UNITED STATES PATENT AND TRADEMARK OFFICE

10/562,203

Office Action Summary	Application No. 10/562,203	Applicant(s) CLEMENT ET AL.	
	Examiner JAN CHRISTOPHER MERENE	Art Unit 3733

DETAILED ACTION

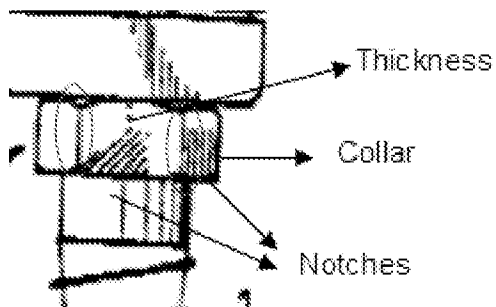
Regarding **Claim 1**, Taylor discloses a vertebral osteosynthesis equipment comprising an anchoring member with a proximal stud and body (see Fig below) with threads (#4), where the proximal stud articulates with respect to the body (see Col 5 lines 5-7), the proximal stud comprises an articulation head with a spherical cap, a threaded cylindrical portion extending from a top of the cap (as seen in Fig below), where a maximum diameter of the cap is at the distal most end (see Fig below as indicated by the dashed line), the body comprises a crimped wall defining a cavity surrounding the cap with an at least partially hemispherical external proximal form (as seen in Fig below), a linking rod (#2), connecting parts (#3), and clamping part (see Fig below).

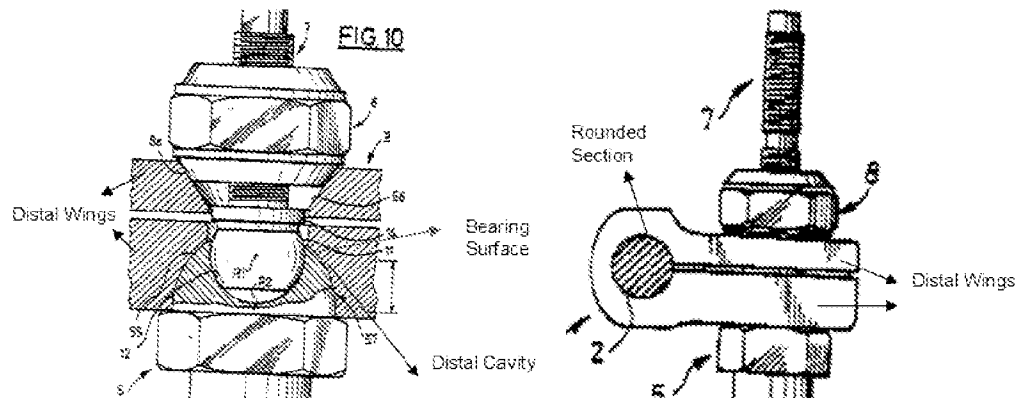
Regarding **Claim 2**, Taylor discloses a proximal gripping portion comprising a collar with a plural of radial notches extending through an entire thickness of the collar (as seen in Fig below, where the notches are circled).

Regarding **Claim 4**, Taylor discloses the connecting part has a rounded section, two parallel distal wings, a distal cavity with a greater diameter than the crimped wall which rests against the crimped wall (as seen in Fig below).

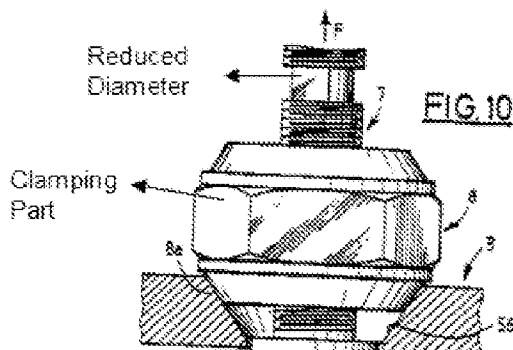
Regarding **Claims 5-6**, Taylor discloses the clamping part/nut engages the threaded cylindrical portion and is seated in a proximal cavity of the proximal branch of the connecting part, wherein the proximal cavity and nut are conical in shape (as seen in fig below).

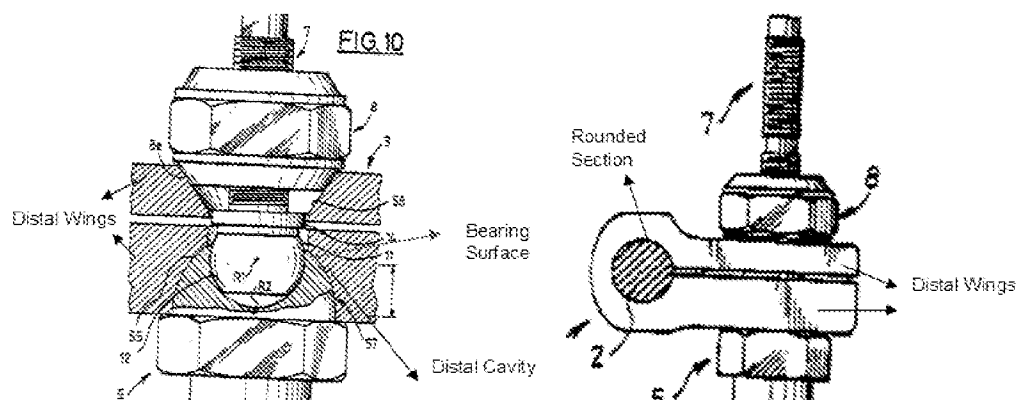
Regarding **Claims 7, 15, 14**, Taylor discloses the stud exhibits a zone of reduced diameter capable of breaking off (as seen in Fig below and see Col 5 lines 54-60).

Regarding **Claim 10**, Taylor discloses that the crimped wall is at least partially hemispherical around the articulation head (see Fig above).

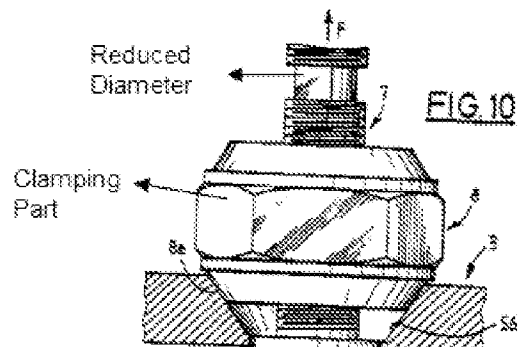
Regarding **Claim 11**, Taylor discloses the connecting part has a rounded section, two parallel distal wings, a distal cavity with a greater diameter than the crimped wall which rests against the crimped wall (as seen in Fig below).

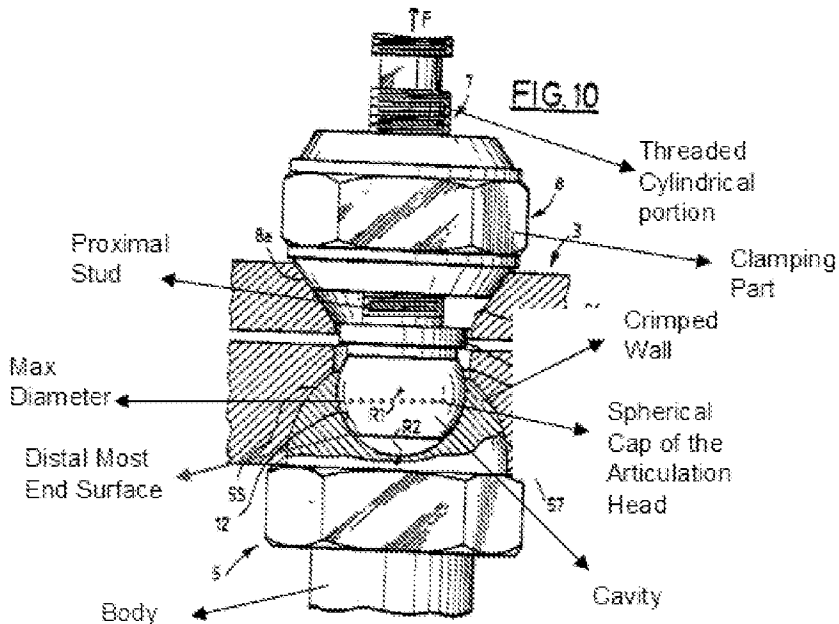
Regarding **Claim 19**, Taylor discloses a vertebral osteosynthesis equipment comprising an anchoring member with a proximal stud and body (see Fig below) with threads (#4), where the proximal stud articulates with respect to the body (see Col 5 lines 5-7) the proximal stud comprises an articulation head with a spherical cap, a threaded cylindrical portion extending from a top of the cap (as seen in Fig below), the body comprises a crimped wall defining a cavity surrounding the cap with an at least partially hemispherical external proximal form (as seen in Fig below), where the largest diameter of the cavity defining a surface facing the distal most end surface of the spherical cap (see Fig below and see Col 5 lines 5-7, where the cap can articulate

within the cavity, where when the most distal end surface can be directed to and facing the largest diameter of the cavity), a linking rod (#2), connecting parts (#3), and clamping part (see Fig below).

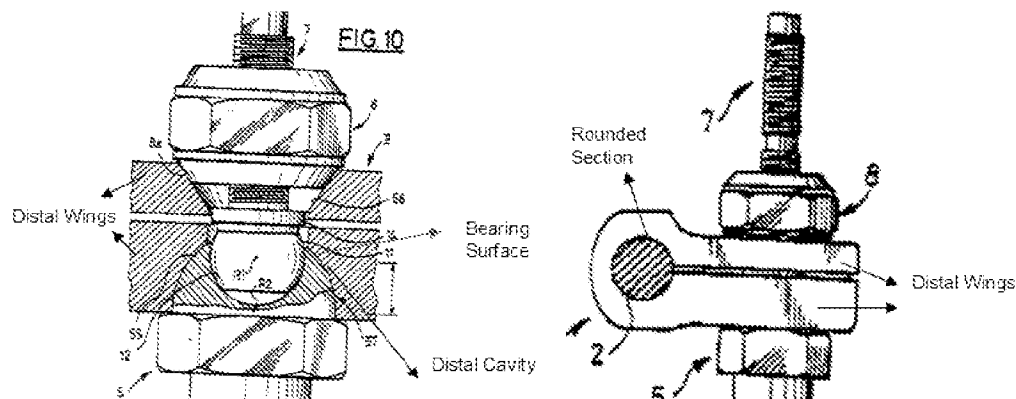
connecting part has a rounded section, two parallel distal wings, a distal cavity with a greater diameter than the crimped wall which rests against the crimped wall (as seen in Fig below) and the proximal stud and connecting part have means (#13, #15 respectfully) to immobilize the proximal stud in rotation with the connecting part (see Col 5 lines 8-20).

Taylor et al does not specifically disclose four notches at 90 degrees to one another.
